## **Town of Arlington, MA Redevelopment Board**

### **Agenda & Meeting Notice July 6, 2020**

##### **Docket #3602, 1207-1211 Mass Ave**

##### **Docket #3625, 882-892 Mass Ave**

9:00 AM

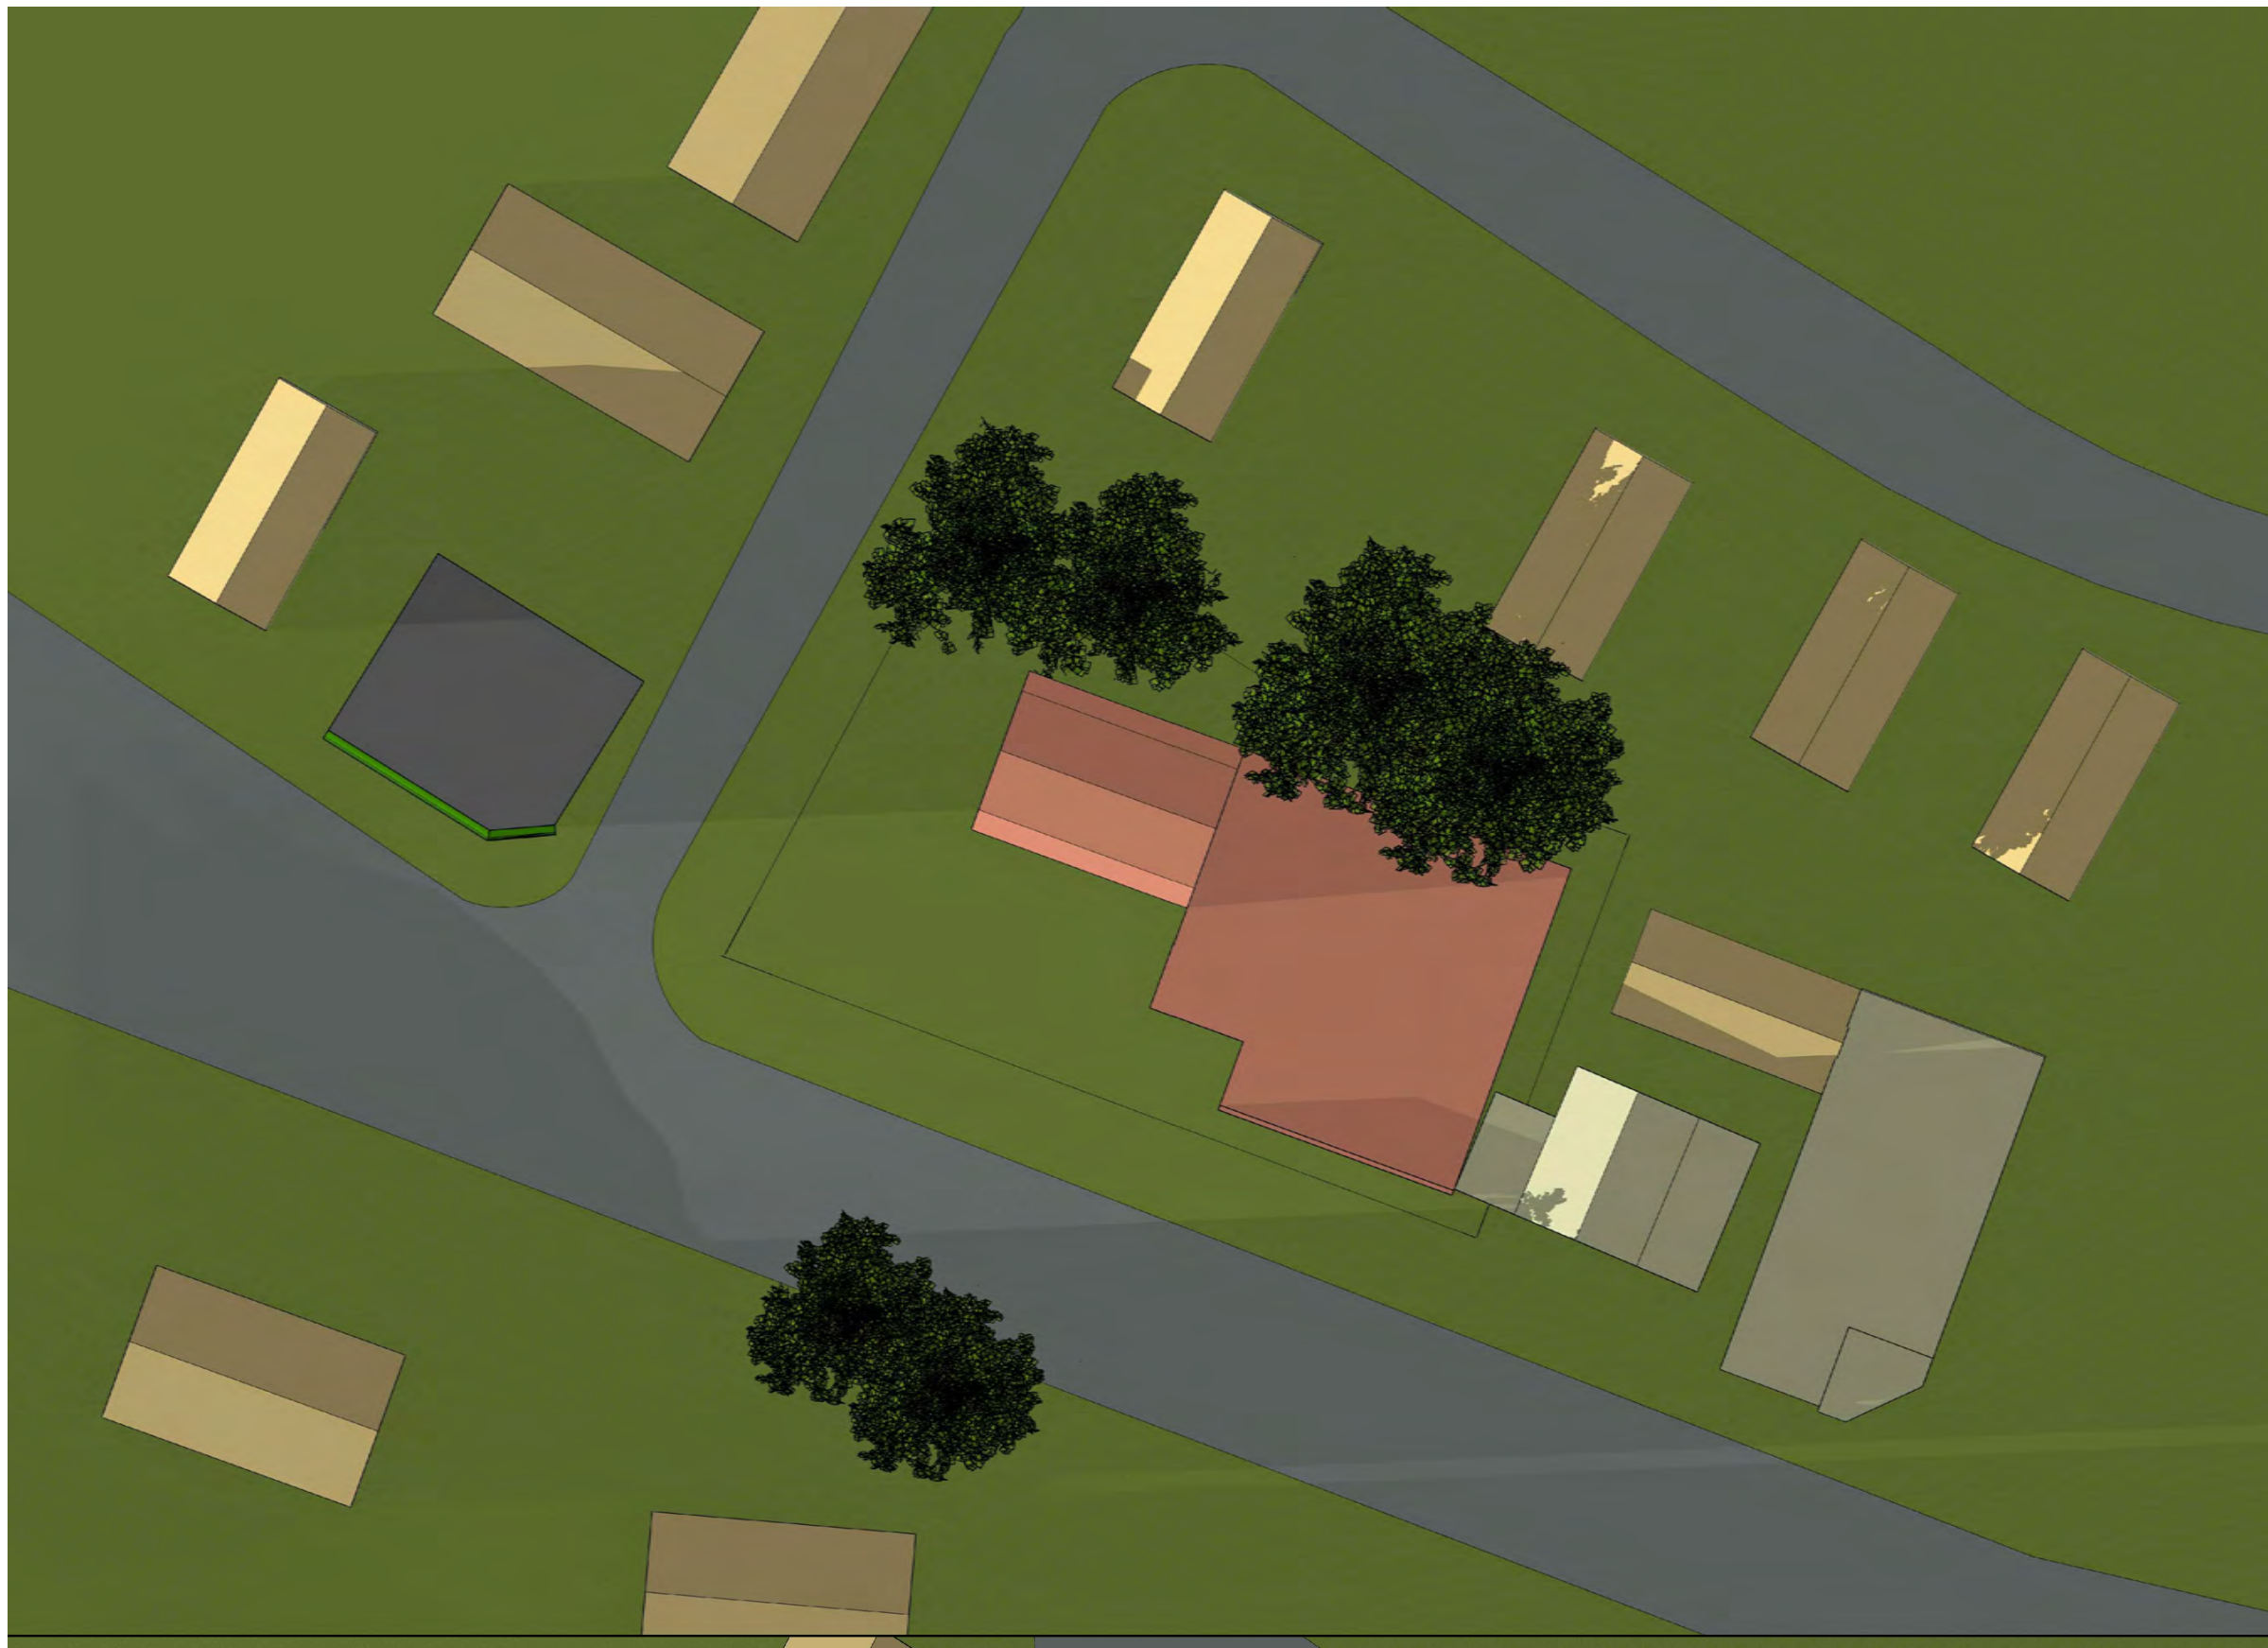
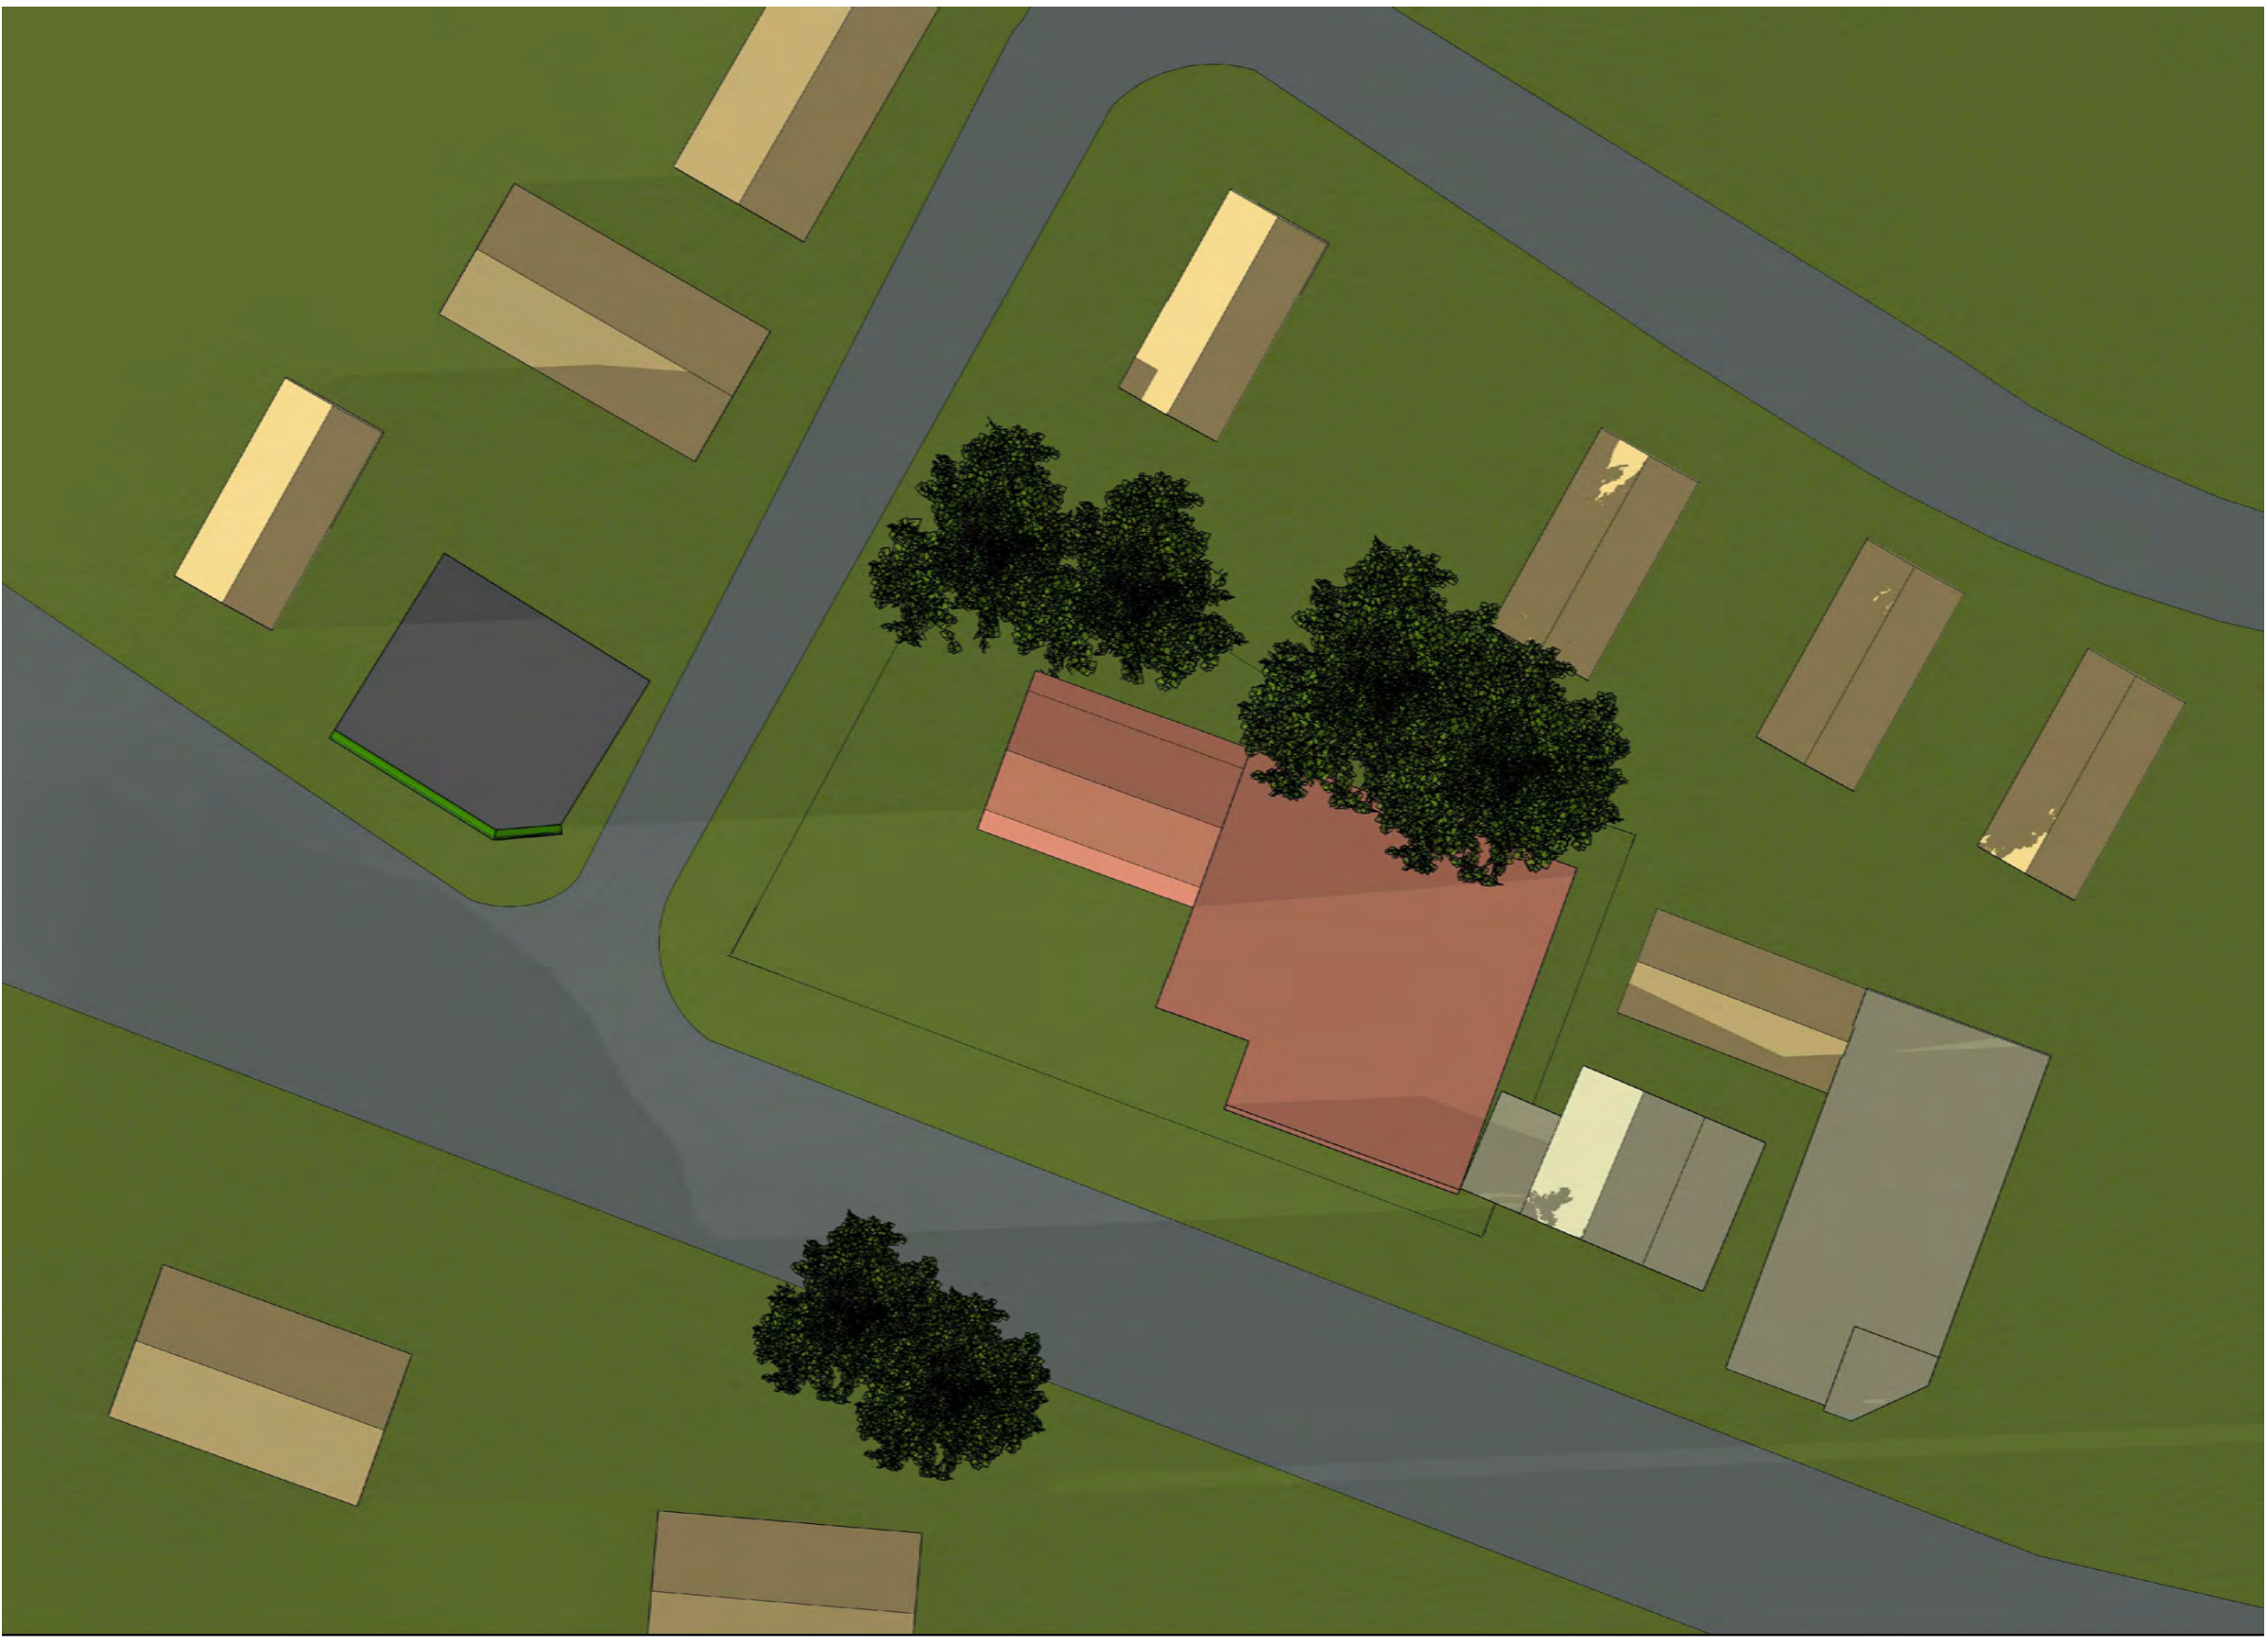
7. Re-evaluate the shadow study previously submitted to consider the existing shadows and provide a comparison and determine any impact to solar arrays in the neighborhood.

7. Take another look at your shadow study, consider the existing shadows and provide a comparison and determine any impact to solar arrays in the neighborhood;

*The plan set includes an updated shadow study based on the new building. The plan set also includes a shadow study documenting the existing conditions of the building and shows trees at the rear of the site.*

*The plan set includes an updated shadow study based on the new building. The plan set also includes a shadow study documenting the existing conditions of the building and shows trees at the rear of the site. The updated materials do not identify if any of the adjacent buildings have solar arrays installed.*
